## **Frodsham Solar**

# **Applicant's Response to Interested Parties' Deadline 3 and 3A Submissions**

Document Ref: EN010153/DR8.36

**Revision P01**

Extract of Fig 7 from APPENDIX 8.4 –  
GEOARCHAEOLOGICAL DESKBASED ASSESSMENT  
Runcorn Carbon Dioxide Spur Pipeline Proposed  
Development (Appendix C of CWCC's Written Representations [REP1-048])

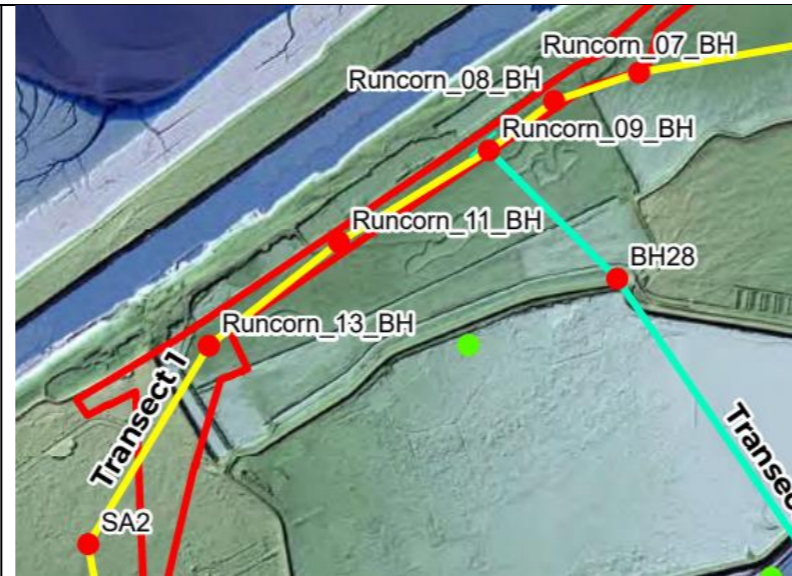
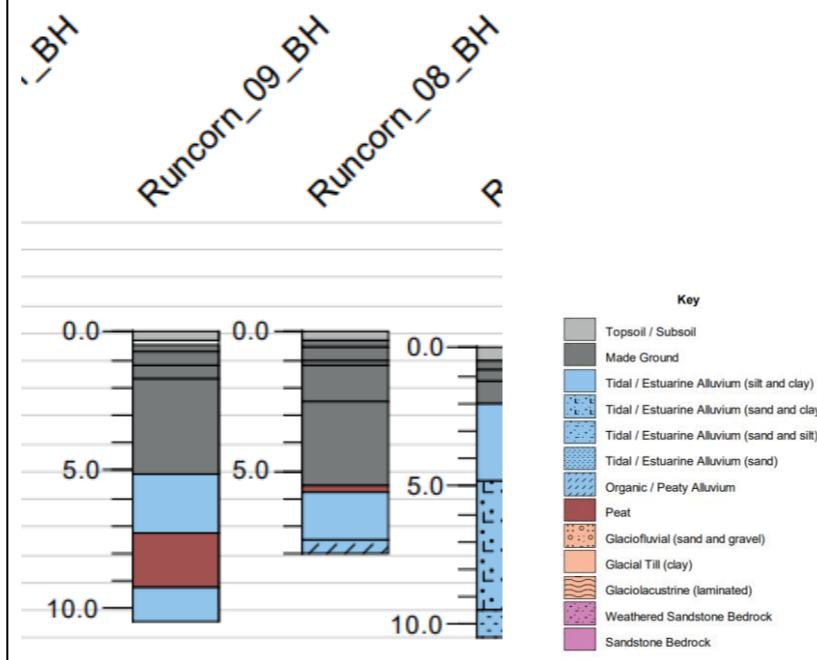
Ref	Document Para number	Document summary point	CWCC comments	Status	Applicant's comments
REP1-043 8.23 Technical Note on Peat Resources - P01					
D3B2.21.01		General	CWCC's comments on peat in its Written Representations [REP1-048] including Appendix A relating to ISH 5g) Peat deposits remain relevant.		Noted.
D3B2.21.02		General	The technical note REP1-043 is welcome to aid understanding of the peat deposits. As confirmed in CWCCs response to ExQ1 (Q6.0.1) [REP2-005] it is considered that the archaeological aspects can be dealt with via Requirement 18 [REP1-004] and the oWSI [AS-029].		Noted
D3B2.21.03	Fig 3.3 Para. 3.7	Figure 3.3: Image showing exploratory hole locations that contain peat and where peat is	CWCCs response to ExQ1 Q6.0.1. [REP2-005] has already noted that Figure 3.3 of the Technical Note on Peat resources reveals peat encountered below 2m within the proposed NBBMA.		The Technical Note on Peat Resources [REP1-043] pulls together a significant volume of ground investigation data, including within the NBBMA, in relation to buried peat deposits. As noted by the Council
